Subject:
Response to Comments on the May 15, 2020 Interim Site Investigation Report
Tyco Fire Technology Center,
2700 Industrial Parkway South, Marinette, Wisconsin
BRRTS Activity#: 02-38-580694

Response to Comments on the May 15, 2020
Interim SIR

Attachment 1 – Soil Isoconcentration Figure

OTA PFOA+PFOS SOIL CONCENTRATION CONTOURS

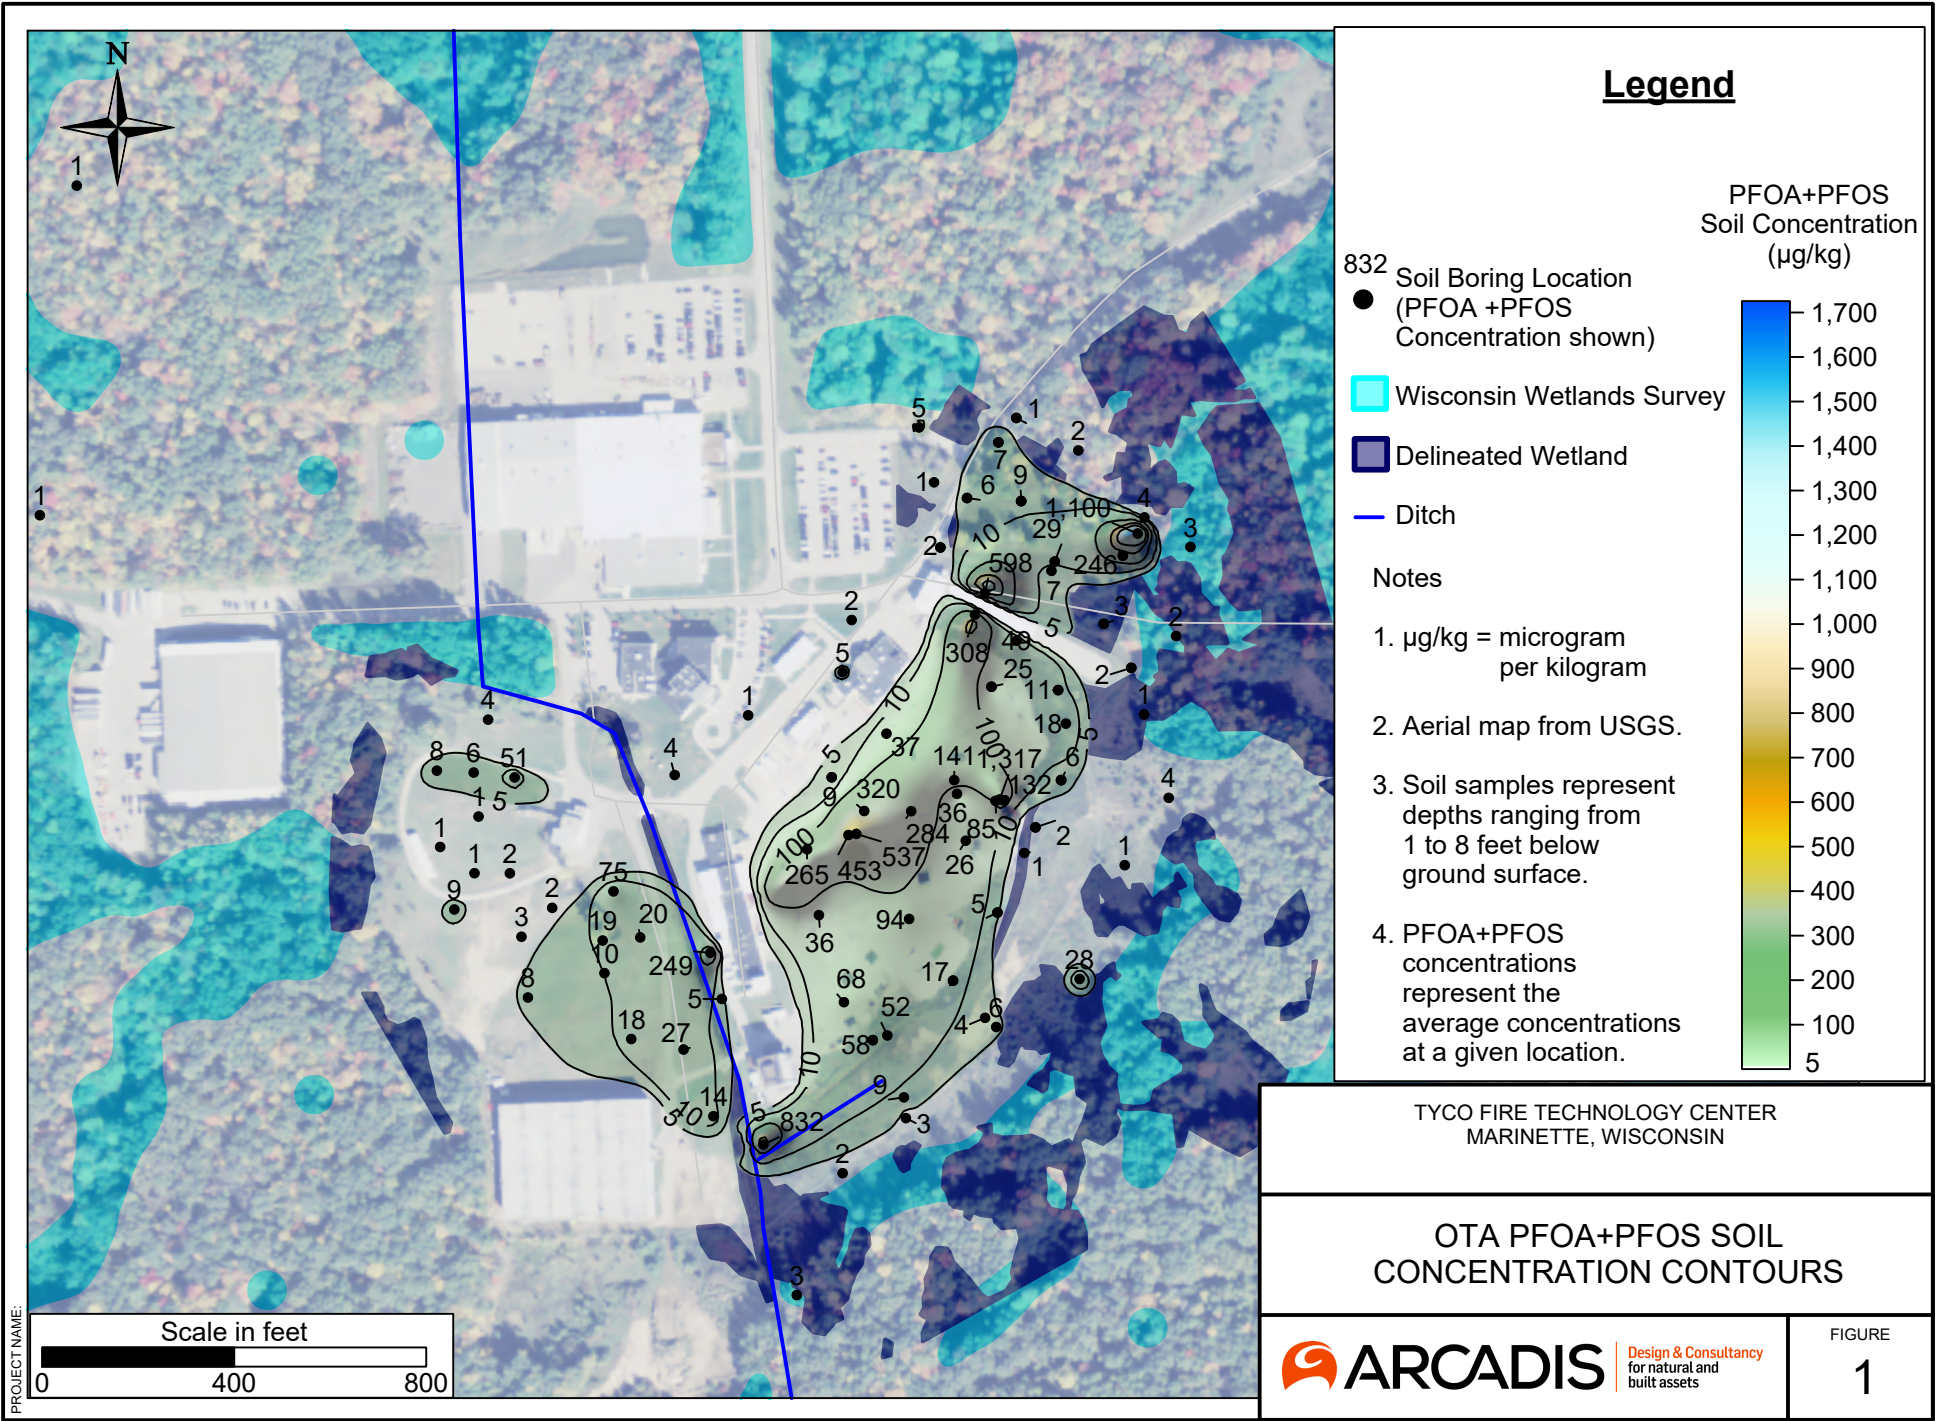
Comment 1: Delineation of PFAS in the presumed FTC source area cannot currently be considered complete. The conclusion in the Report is based on sampling results at 47 on-site locations, none of which were collected from areas where a 2006 excavation to remove petroleum impacts was conducted. The extent of these excavation activities should be mapped to validate this conclusion. In addition, the report does not indicate if any other activities, such as the 2006 excavation, have been conducted at the Site that may have disturbed surface soil (Wis. Admin. Code § NR 716.11(3)(a)).

Comment 2: Other potential source areas at the FTC (i.e., other historical training areas [potentially west of the current OTA], outdoor storage or potential locations of spills, former soil stockpile areas, and similar relevant areas), should be identified, mapped, and evaluated. Both the historical and current operational areas should be evaluated based on the soil data collected to date. An analysis should then be provided that discusses how each area is characterized for PFAS nature and extent. Until this is completed, a determination as to whether the on-site soil contamination has been fully characterized and delineated cannot be made (Wis. Admin. Code § NR 716.11(3)(a)).

Tyco Response: Additional soil sampling was completed in the Fall 2020 to refine soil delineation at the FTC. The additional soil sampling locations were selected to determine whether the former Marine Testing Area (MTA) represents an additional PFAS source area and to complete delineation of shallow soil laterally outward from the OTA and MTA (if needed) to site-specific residual contaminant levels (SSRCLs). The extents of excavations completed to address volatile organic compounds are mapped in Figures C-2 and C-3 of the attached May 2007 Soil Excavation Documentation Report, prepared by Earth Tech Inc. No soil samples were subsequently collected and analyzed for PFAS within areas that were excavated.

Additional soil sampling was completed in the Fall 2020 at the FTC. . One of the objectives for the soil sampling were to determine whether the former Marine Testing Area (MTA) represents an additional PFAS source area.
